City of Santa Fe, New Mexico

memo

2024-008628-HDRB, 216 Old Santa Fe Trail, Downtown & Eastside Historic District, Non-contributing. John Padilla, agent for Lewis West, owner, proposes to replace windows and doors. An exception is requested to 14-5.2(E)(1)(c) for installing windowpanes larger than thirty inches.

Figure 2: Red indicating the alterations by circa 2016 addition and other alterations

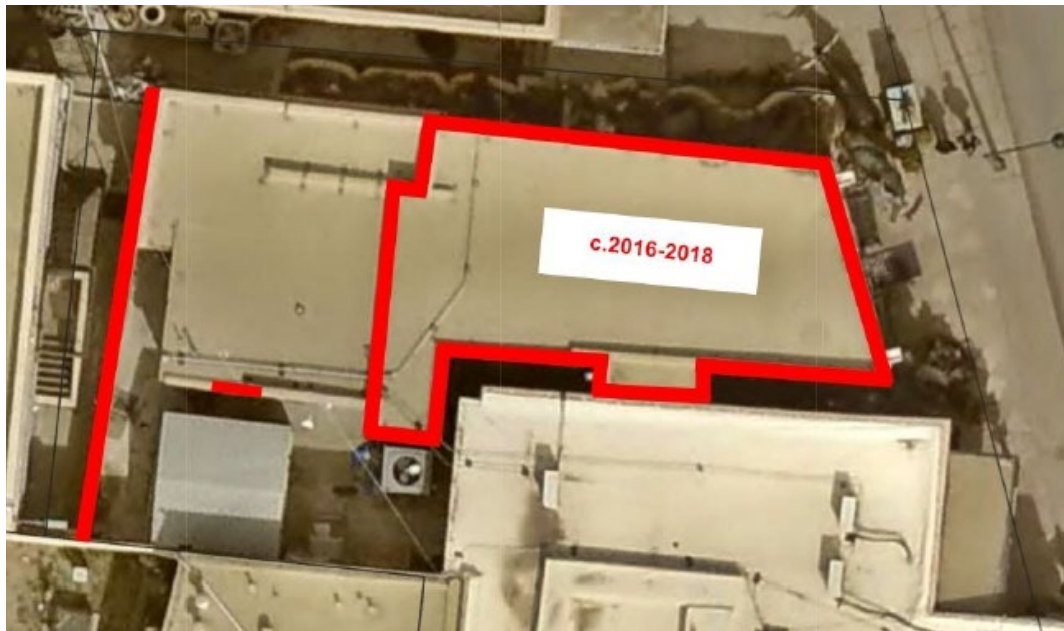
Additional work on the property in 2017 altered the face of the structure by enclosing windows and increasing the size of fenestrations to create the store front as it appears in 2022.

The structure as it exists today has no fenestrations on either the north or south elevations. The east elevation was altered again in 2023 creating a glass front and while the single header from the 2016 conversion is still present an awning has been installed above the header but below the parapet height.

Figure 4: Proposed East Elevation under case H-16-007.

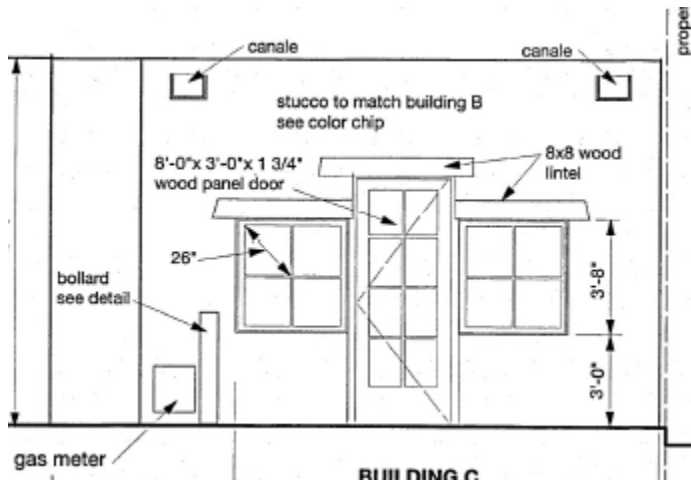
Staff Response: Staff finds that this criterion has not been met. The large open glazing is not in keeping with the historic character of the streetscape. The streetscape of 216 Old Santa Fe Trail is predominately divide lite windows, with few exceptions which cannot be substantiated as approved.

Furthermore, the historic case H-16-007 two windows and a door with divided lites were requested (please see Figure 4).
